FlexLogix Controller Revision 11

Cat. No. 1794-L33, 1794-L34, and 1794-L34/B

Publication 1794-RN001T-EN-P - April 2004

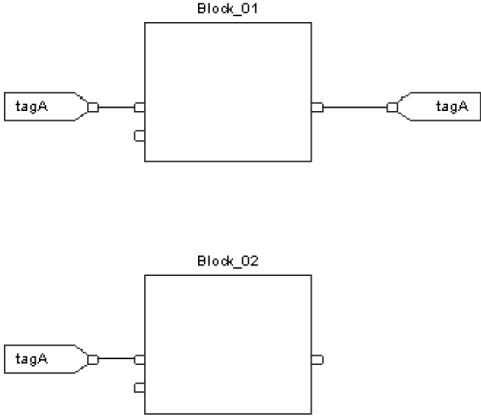
Online Editing of Function Block Routines	<p>This revision lets you edit function block routines (diagrams) while online with the controller.</p> <ul style="list-style-type: none"> • Online edits include changes to logic, sheet names, pin visibility, block locations, etc. • You edit a function block routine the way you edit a ladder routine: start a pending edit, accept the edit, test the edit, and finally assemble the edit.
